TREE SURVEY REPORT

7 KENILWORTH ROAD
BRIDGE OF ALLAN

SURVEY OVERMARKED TO UPDATE REMOVED TREES 12/4/24,
BY ALLY CROLL ARCHITECT LTD FOR PLANNING PURPOSES.

JOB	7 Kenilworth Road, Bridge of Allan	 WOODLAND DESIGN AND MANAGEMENT CONSERVATION AND ARBORICULTURE Tel: 01259 743 212 Fax: 01259 743073 e-mail: consultants@eamonnmwall.co.uk
TITLE	Tree Survey Plan	
SCALE	1:350 @ A4	
OSGR	NS 795 974 	
DATE	April 2023

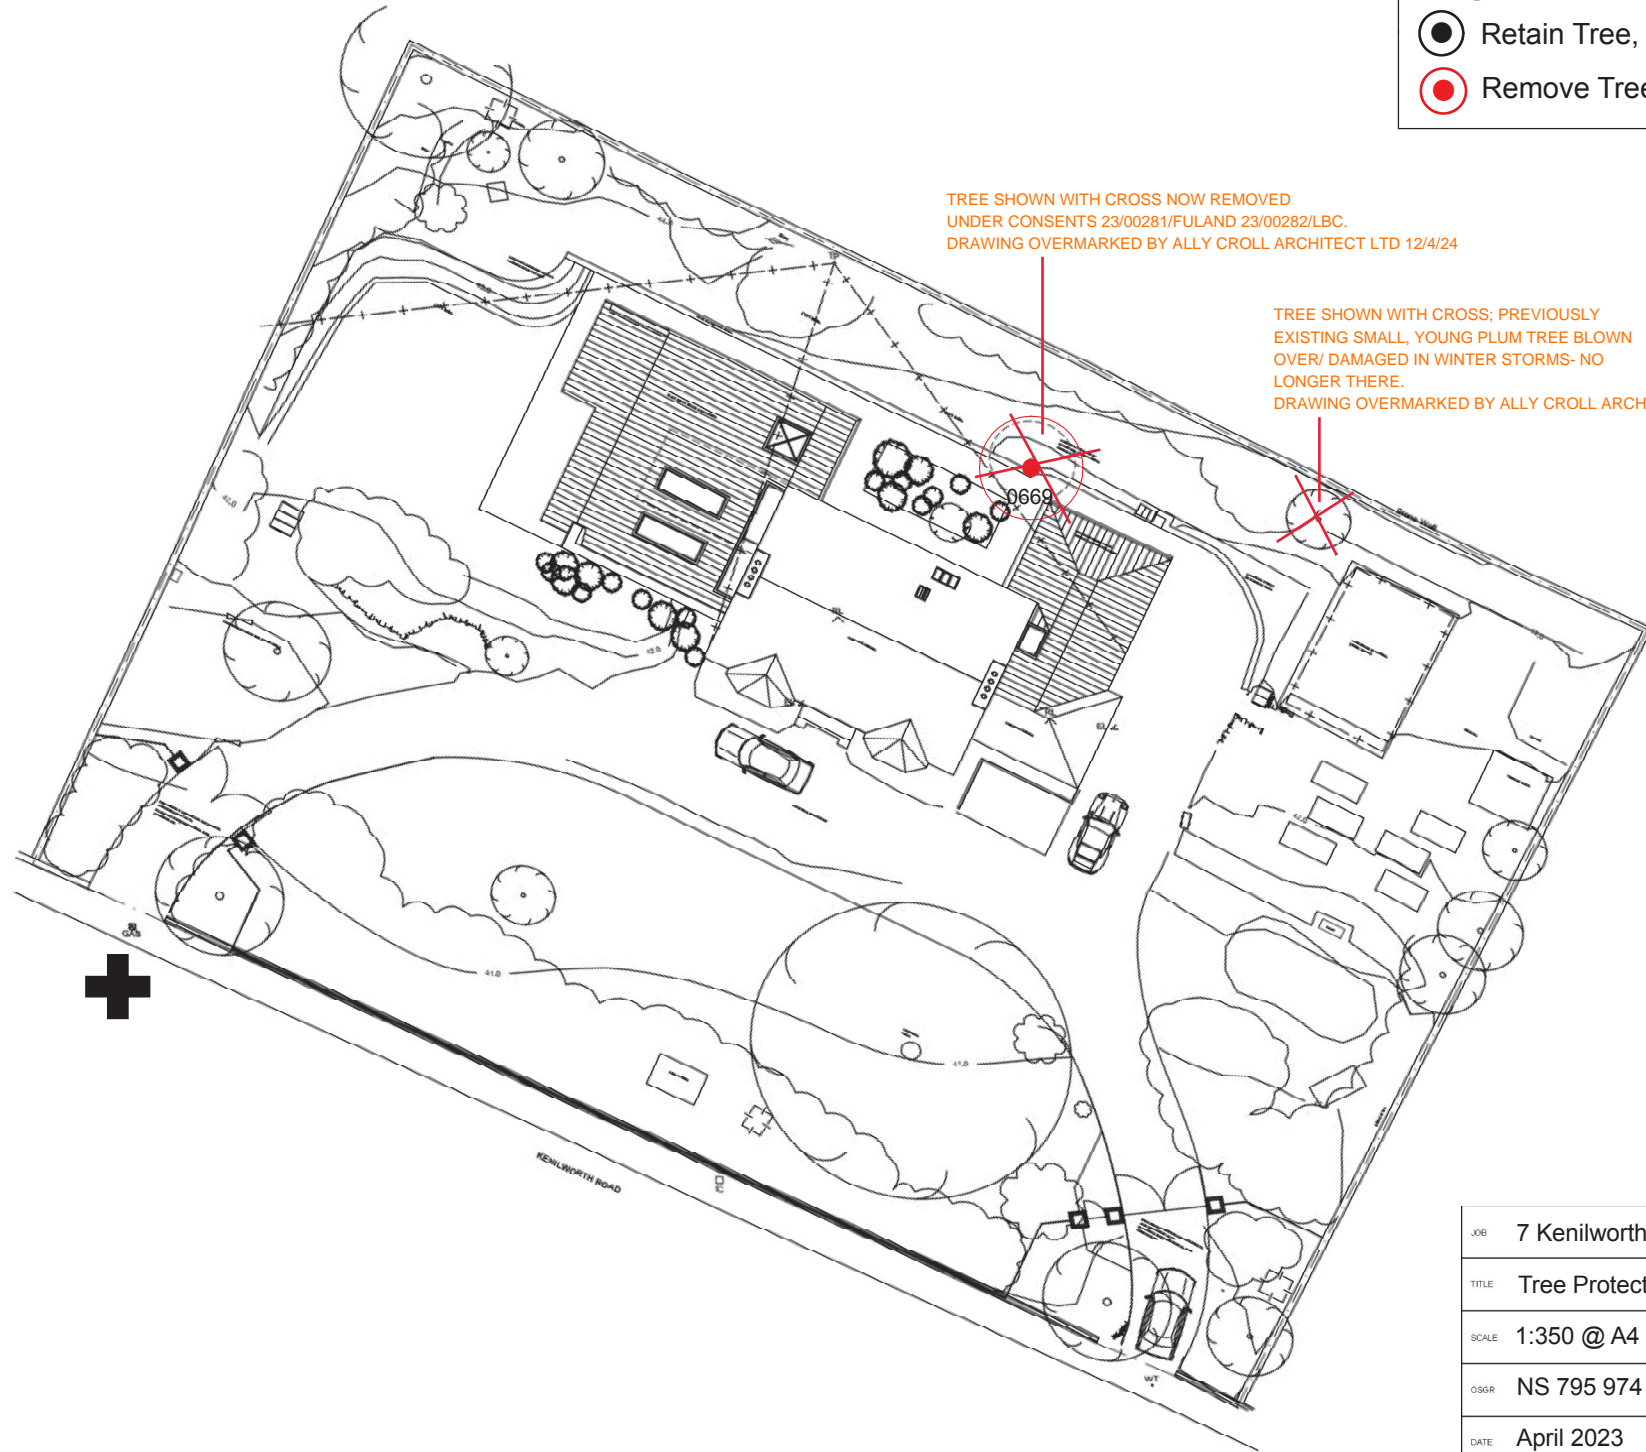
TREE SHOWN WITH CROSS NOW REMOVED
UNDER CONSENTS 23/00281/FULAND 23/00282/LBC.
DRAWING OVERMARKED BY ALLY CROLL ARCHITECT LTD 12/4/24

TREE SHOWN WITH CROSS; PREVIOUSLY
EXISTING SMALL, YOUNG PLUM TREE BLOWN
OVER/ DAMAGED IN WINTER STORMS- NO
LONGER THERE
DRAWING OVERMARKED BY ALLY CROLL ARCHITECT LTD 12/4/24
